# INNER WEST COUNCIL

## DEVELOPMENT ASSESSMENT REPORT

<b>Application No.</b>	10.2018.96
<b>Address</b>	47 Wolseley Street, Haberfield
<b>Proposal</b>	Alterations and additions to an existing dwelling
<b>Date of Lodgement</b>	10 July 2018
<b>Applicant</b>	Form Architects
<b>Owner</b>	Salvatore Orti-Tullo
<b>Number of Submissions</b>	Two (2)
<b>Value of works</b>	\$240,780.00
<b>Reason for determination at Planning Panel</b>	Variation to the maximum building height control exceeds 10%.
<b>Main Issues</b>	Variation to the maximum building height control, non-compliance with clause 6.5 (3)(c) of the Ashfield LEP 2013, two submissions relating to privacy.
<b>Recommendation</b>	Conditional Approval

Picture 2 – Section showing height control plane.

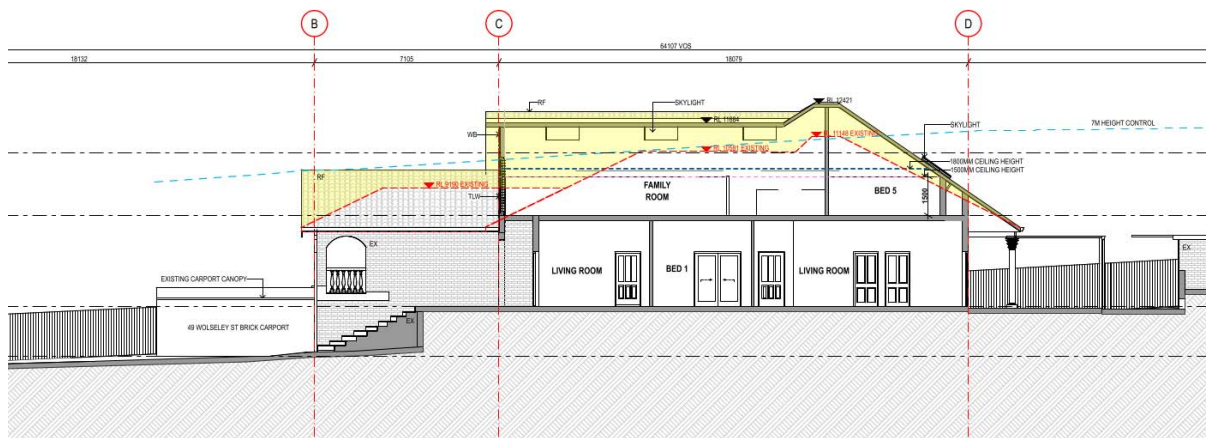
The development has a maximum building height of 7.8 meters and thereby exceeds the maximum height of 7.0m of the development standard prescribed under Clause 4.3 of ALEP 2013.
